**Re: ATCO Pipelines  
Radiographic Weld Inspection**

**ATCO-AUC-2016JUN27-001**

**ATCO-AUC-2016JUN27-002**

**ATCO-AUC-2016JUN27-003**

ATCO-AUC-2016JUN27-003(a)

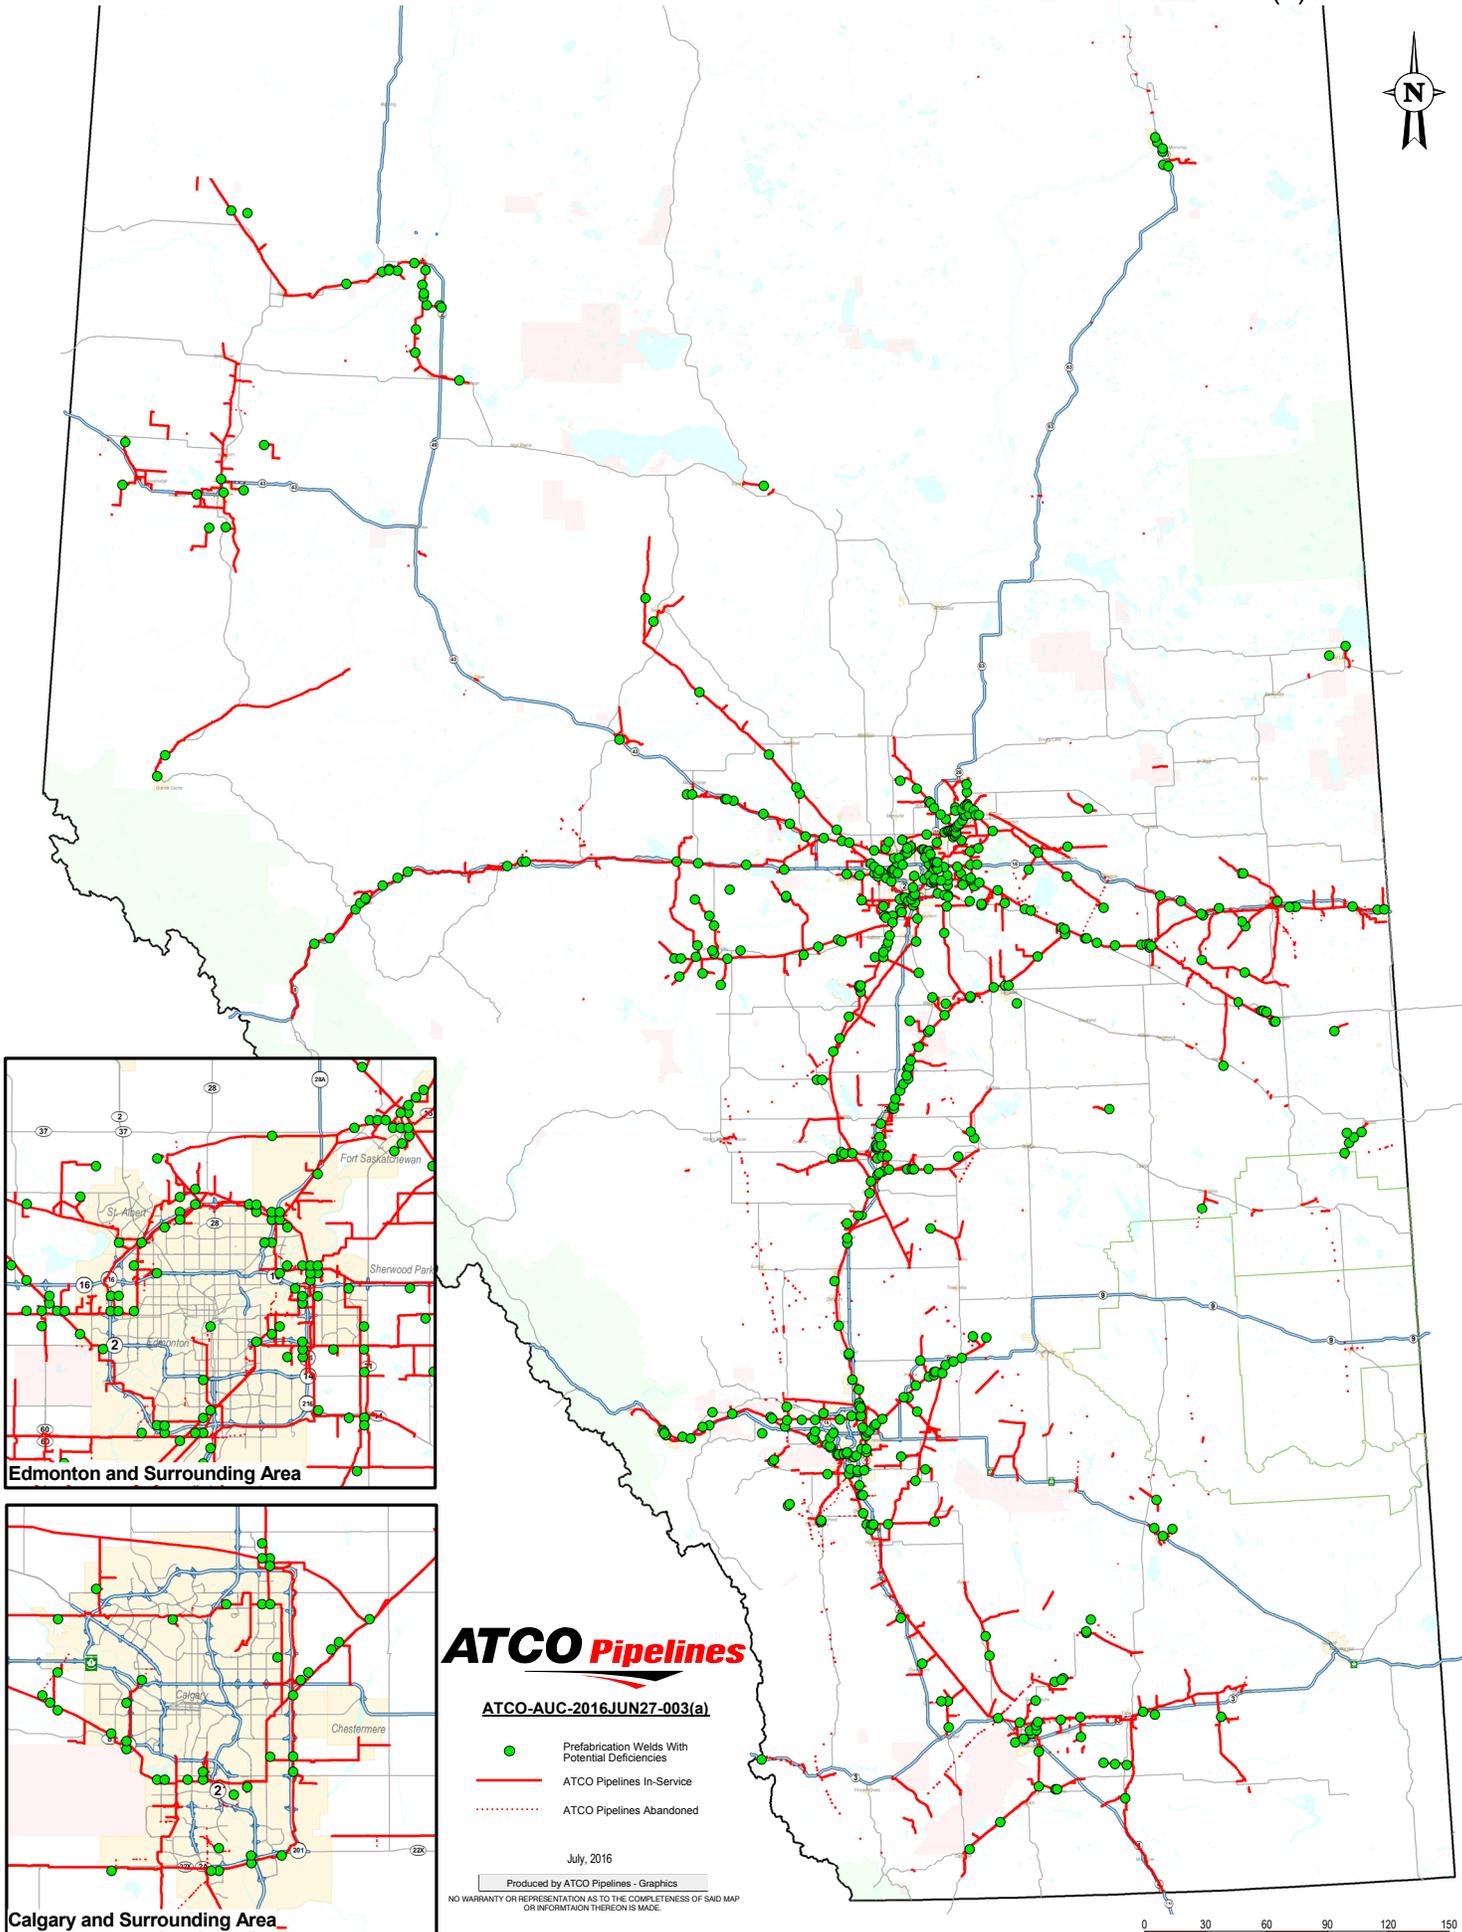
- (a) Please provide an ATCO system map indicating each of the 378 geographic locations having prefabrication welds with potential deficiencies.
- (b) Please provide an updated status on re-inspections that includes a complete listing of all affected pre-fabrication welds correlated to geographic location, with corresponding status (e.g., date assessed, assessment disposition and basis for decision, date re-inspected, re-inspection disposition, tentative repair date, repair status, final acceptance date).
- (c) Please explain whether the deration at all 24 of the re-inspected sites arose from weld defects identified at each of these locations or other factors.
- (d) Please explain the methodology utilized to analyze the individual defects.
- (e) Please explain the methodology utilized to establish the reduced operating pressure.

- (a) Please refer to ATCO-AUC-2016JUNE27-003(a) Attachment, which includes an ATCO system map indicating each of the 378 geographic locations having prefabrication welds with potential deficiencies.
